SOUTHERN CALIFORNIA EDISON
KERN RIVER NO. 3 HYDROPROJECT

DOCKET NO. P-2290-122

**KERN RIVER BOATERS' COMMENTS AND STUDY
REQUESTS IN RESPONSE TO ISR SUPPLEMENTS**

KERN RIVER BOATERS' COMMENTS AND STUDY
REQUESTS IN RESPONSE TO ISR REPLIES

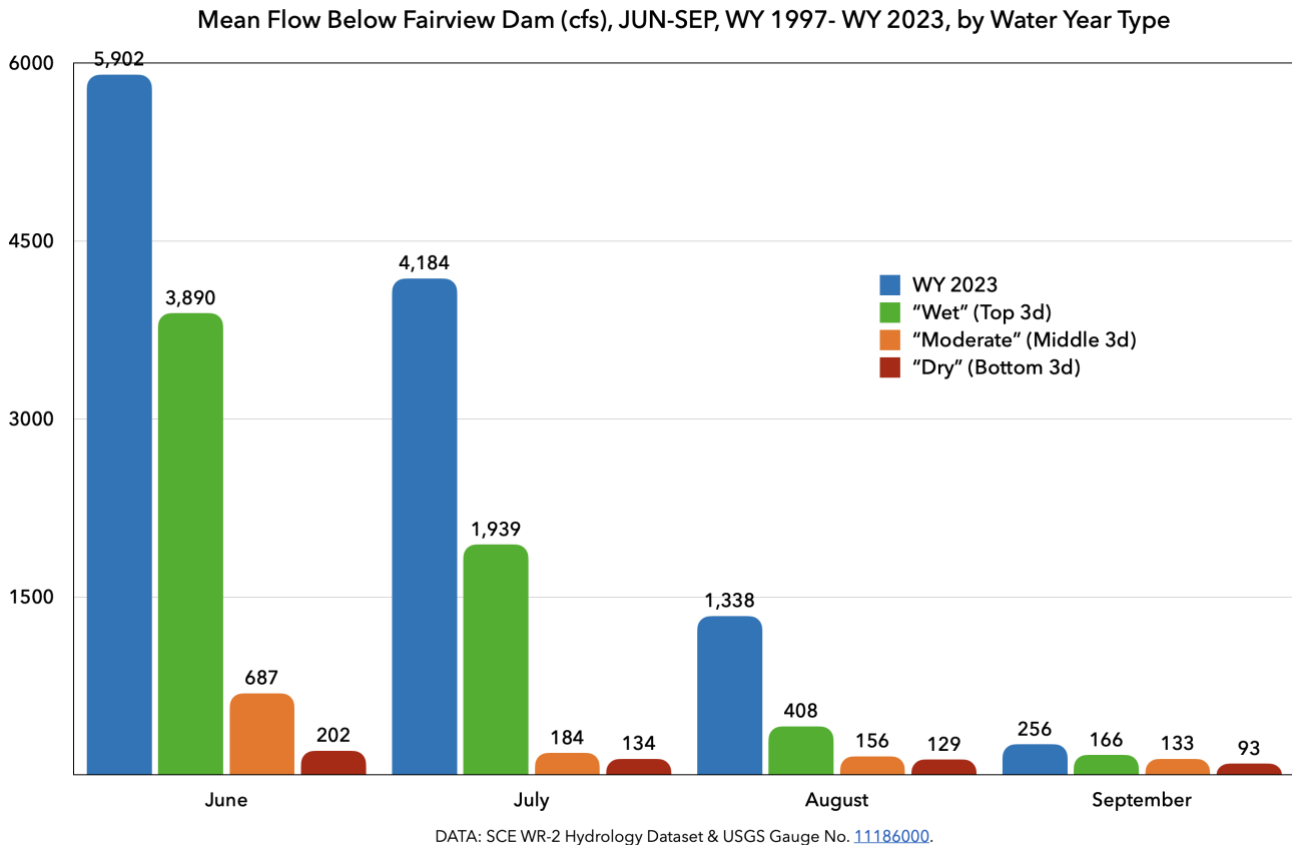
For a broader perspective, we used the KR3 hydrology dataset (WY1997-2022) and USGS data (WY2023) to obtain daily mean flows below Fairview Dam. We then segregated those 27 water years into three equal groups of nine — wet, moderate, and dry years. We then calculated the mean flow below Fairview Dam for each of the summer months within each water year type and compared those figures with those from 2023. Here is the result⁴⁸:

As vividly apparent, the figures for 2023 are well above even the “wet” year averages and absolutely dwarf the moderate and dry year averages.

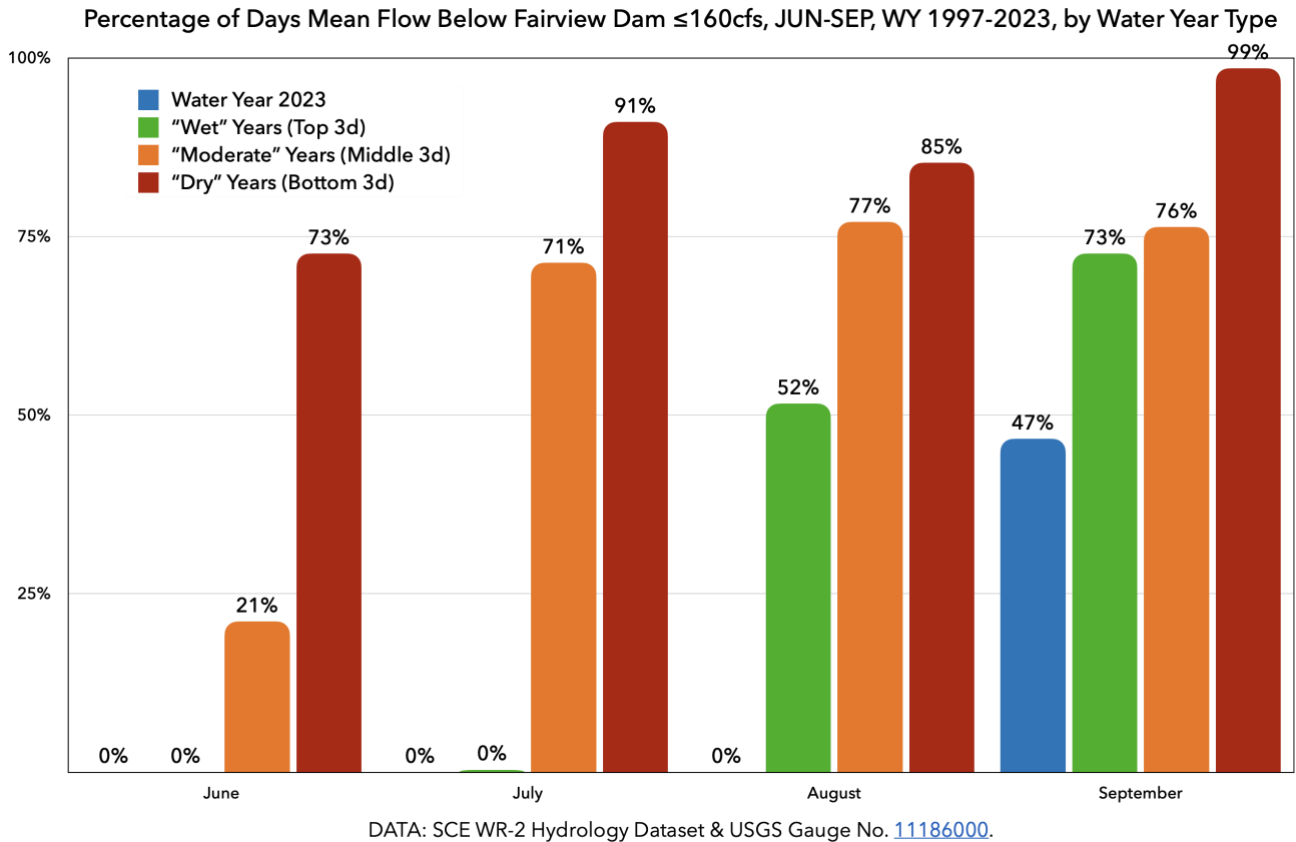
We applied the same methodology to determine the percentage of days per month flows were at or near fish flow (under 160 cfs), by summer month and water year type⁴⁹:

This data shows that flows near the MIF generally set in below Fairview Dam by early June in dry years and by early July in moderate years. They did not set in during 2023 until late September — two to three months later than usual, and well after the summer recreation season was over. Results from summer 2023 REC-2 studies are accordingly results from a river that, quite literally, almost never exists. The data shows that a vast majority of the time summer recreators are confronted with hydrology near or at fish flow — far, far, far below the levels they were gifted in 2023. Conditions in summer 2023 were extremely anomalous and merit the extension of the REC-2 study through September 2024, at a minimum. FERC specifically tells the public: “section 5.15 (d) of the ILP permits stakeholders to request additional years of study if good cause is shown. Good cause could include equipment failures, drought, new endangered species listings, etc.”⁵⁰ Surely a 50-year deluge as seen in WY2023 is as anomalous or out of the ordinary as drought, which occurs with much greater frequency. Edison’s assertion to the contrary should carry the weight of the evidence and analysis it is based on — none.
